A.C. Wright Design		
Sheet: /		
File: ACE_RAM_Patch.kicad_sch		
Title: ACE RAM Patch		
Size: A4	Date: 2026-09-24	**Rev: 1.1**
KiCad E.D.A. 10.0.3		Id: 1/1

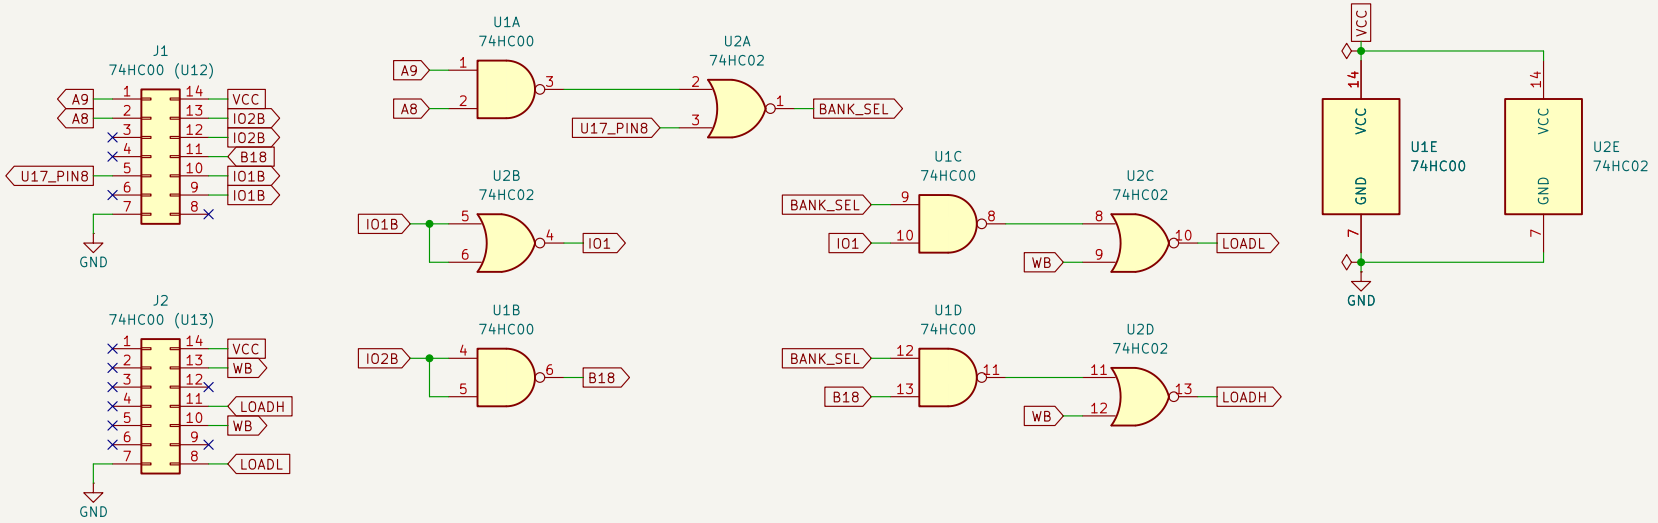
Fitting: take U12 and U13, chips and sockets, off the Rev 1.0 ACE Board. The patch mounts underneath it, front side up: pin headers from J1 go into U12's holes and from J2 into U13's, soldered on both boards. U1 and U2 are on the back, hanging below; trim their leads flush on the front. U13's pin 1 is 23.00 mm from U12's along the row, so J2 sits 23.00 mm from J1.

LOADL and LOADH go high only on a write to the bank register, $83FF or $87FF, while PHI2 is high: A9·A8·(A0–A7 all ones), with IO1 for LOADL and B18 for LOADH, and /WB. U17_PIN8 is the 74HC30's output, /(A0–A7).
